# Windermere Estates

Waterford, Connecticut

Environmental Review Team  
Report

ENVIRONMENTAL REVIEW TEAM REPORT  
ON  
WINDEMERE SUBDIVISION  
WATERFORD, CONNECTICUT

# Drainage Areas

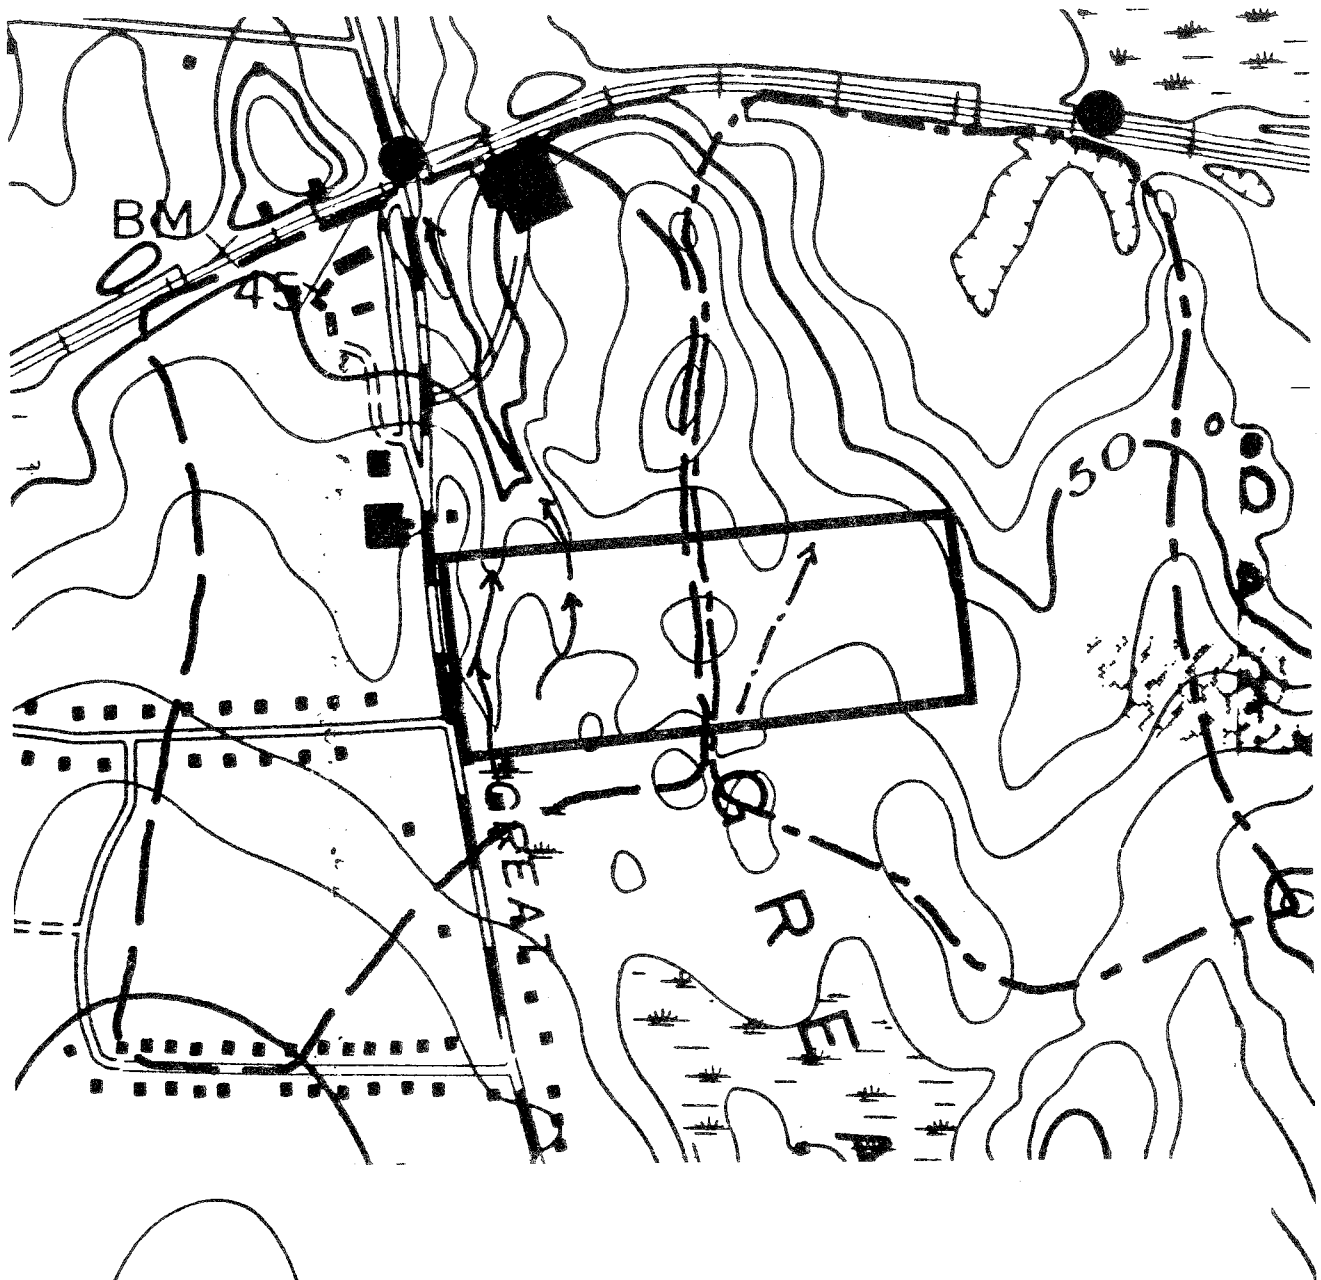
For the purpose of analyzing the runoff changes likely to occur under the present plans, the parcel was divided into two areas. These areas are delineated on the Watershed Boundary Map. It is assumed the project engineer for the subdivision will break the drainage areas down similarly when addressing pre- and post-runoff changes. Each drainage area is based upon a particular point of outflow and shows all the land from which surface runoff ultimately reaches that point. It should be noted that the watershed boundaries shown may not account for possible drainage re-routing through man made structures.

As shown by the above table, it is estimated that development in each of the drainage areas depicted would increase the curve number of the property by 2 (57 to 59 for drainage area I and 70 to 72 for drainage area II). The percent increases in runoff depths are slightly higher for Drainage Area I. Under these conditions, runoff depths for a 25-year storm event in Drainage Area I would increase from 1.49 inches to 1.65 inches; an increase of about 11 percent. In Drainage Area II, the runoff depths for a 25-year storm would increase from 2.57 inches to 2.75 inches; and increase of 7%. These increases are significant and underscore the need of judicious stormwater management on the site. Prior to subdivision approval, it is recommended the applicant be required to submit detailed hydrological information on pre- and post-development runoff volumes as well as peak flows from the site. Estimates should be provided for a 10, 25, 50 and 100-year design storm. In addition, the project engineer should take a close look at downstream culverts to assure that they have capacity to handle post-development flows from the site.

Based upon present plans, stormwater drainage emanating from Peggy Lane will be artificially collected in catch basins and ultimately discharged into wetland areas on the site. As mentioned earlier, wetland areas can act as natural runoff retention basins, thereby reducing downstream flooding during storms. For this reason, every effort should be made to minimize wetland fillings and/or modifications. The applicant's engineer should examine the wetland area receiving the stormwater runoff to determine if they can adequately store the projected peak flows following development.

# Vegetation

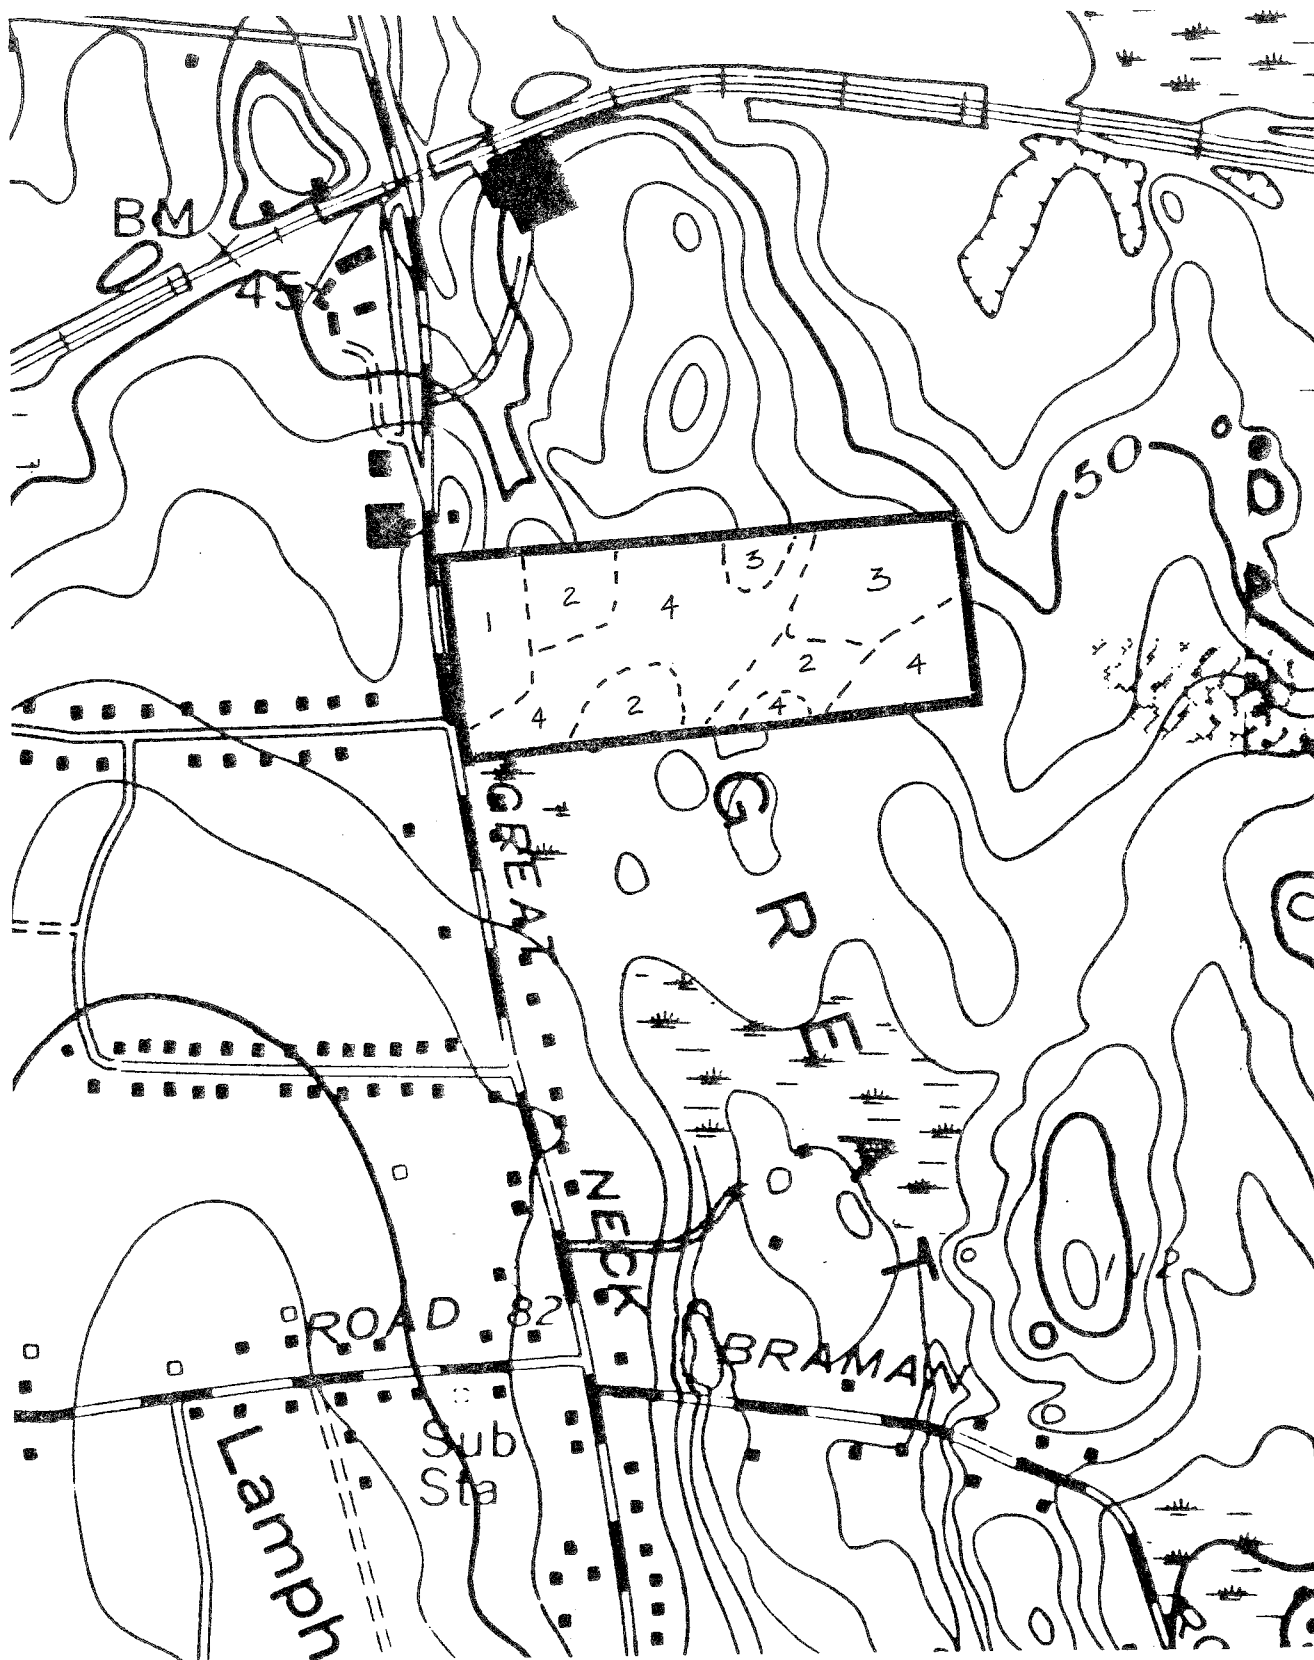
Development of this property is going to require considerable fill on the roads, driveways, and on some of the house lots. Although the plans provide for a series of culverts, it is inevitable that changes in the water table will occur, due either to impeded water flow or increased water volumes from the clearing and paving. This will have a disastrous effect on whole stands of trees. The mortality may take two to three years or more to become evident, and the homeowner who has bought a house on a wooded lot is going to be very disappointed in a few years time.

Another problem is going to be trees being blown over by the wind. Trees growing on these poorly drained soils have very shallow root systems and long thin boles, making them subject to storm damage. Severe tree loss problems should be expected if this site is developed as planned.
